City Planning Department

Memo

To: Cranston City Plan Commission
From: Doug McLean, AICP - Principal Planner / Administrative Officer
Date: October 28, 2020
Re: **Timothy and Ann Hickey, Two (2) Variance Requests Requiring Plan Commission Recommendations**

Location: 1626 Scituate Avenue, AP 34, Lots 25 and 32

SITE PLAN (Zoom in)

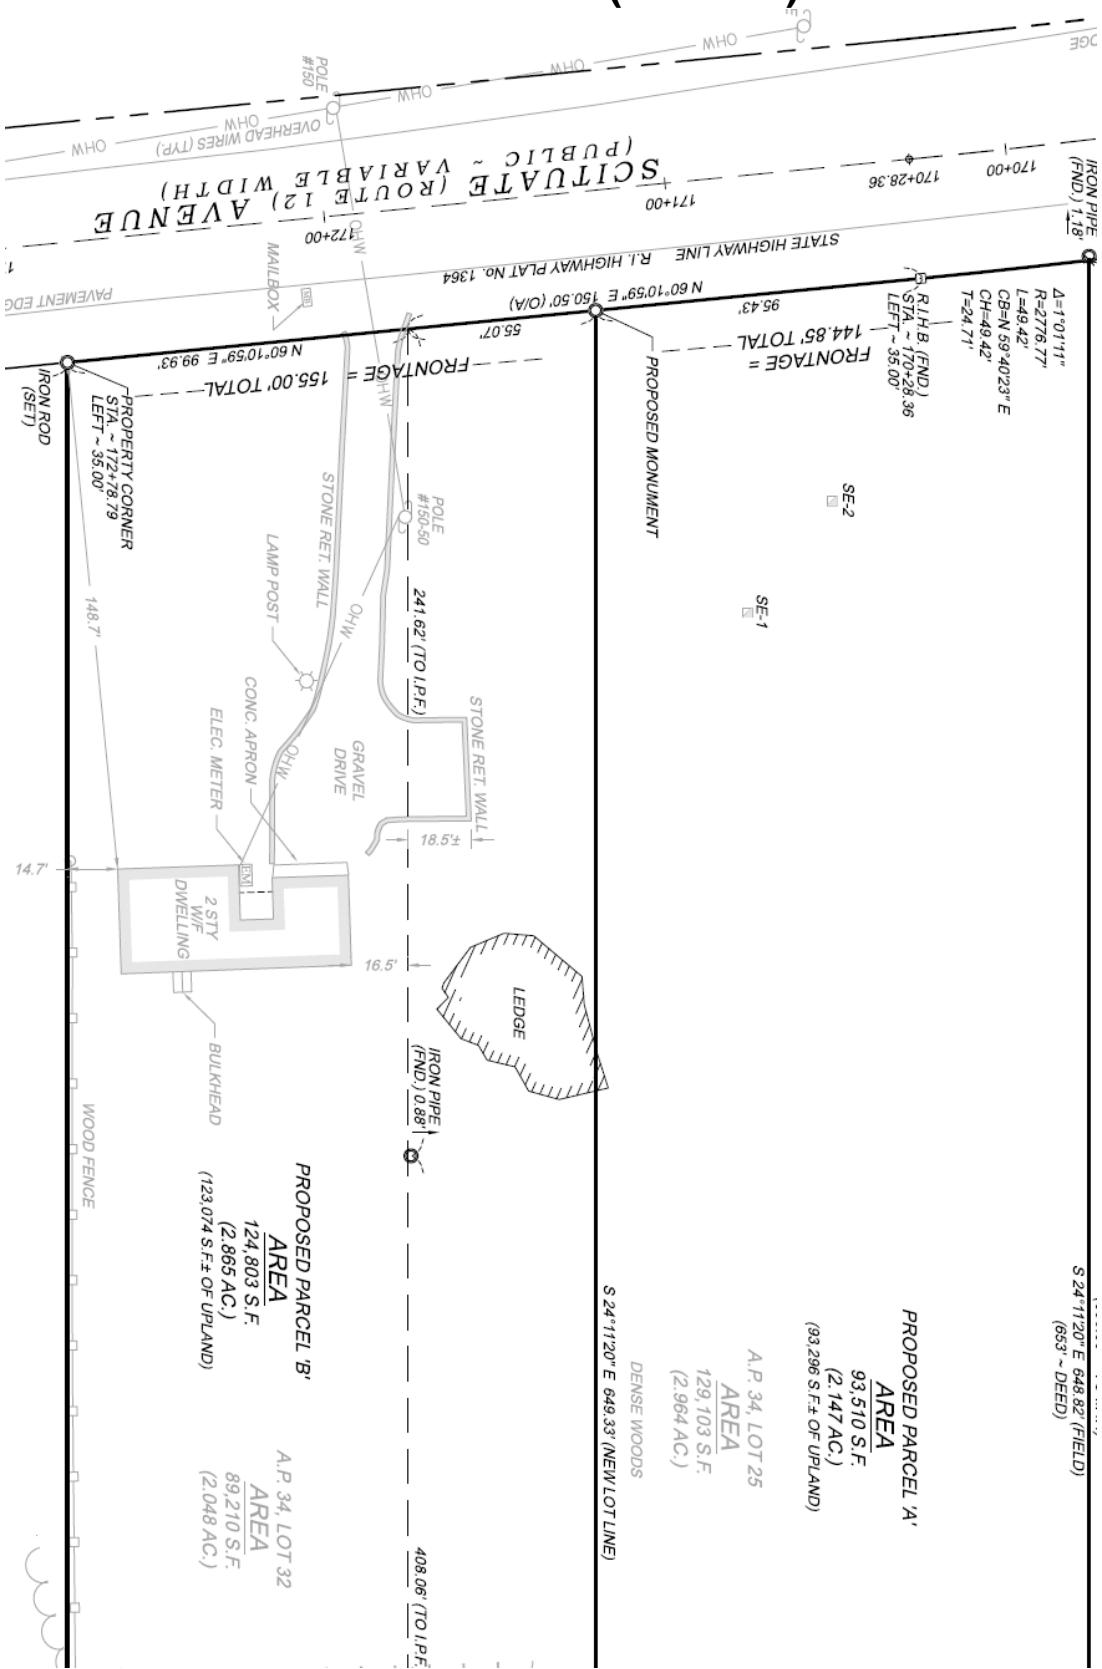
- 1) The overall proposal is to relocate an existing side property line that would result in 2 variance requests for substandard frontage (for lots 25 and 32 respectively) and a variance request to allow an irregular side lot line (for lot 32) that does not extend straight from the front of lot to the rear of lot.

- 6) The result of the administrative subdivision is that the 2 lots would have a more even distribution of frontage and lot area as follows:
 - a. The lots currently have approximately 100 and 200 feet of frontage, for lots 32 and 25 respectively. The proposed lots would have approximately 155 and 145 feet of frontage for lots 32 and 25 respectively.

- b. The lots currently have approximately 89,210 ft² and 129,103 ft² of lot area, for lots 32 and 25 respectively. The proposed lots would have approximately 124,803 ft² and 93,510 ft² of lot area for lots 32 and 25 respectively.

- 7) The lot that is increasing in both frontage and acreage is the lot that contains the existing single family home.
- 8) The proposed irregular side lot line stems from a pre-existing condition relating to the abnormal depths of the 2 existing lots.

Due to the fact that the application is consistent with the Cranston Comprehensive Plan, and due to the fact that the application will not increase the housing density level beyond what is allowed by-right in zoning, staff recommends the Plan Commission forward a **positive recommendation** on this application to the Zoning Board of Review.
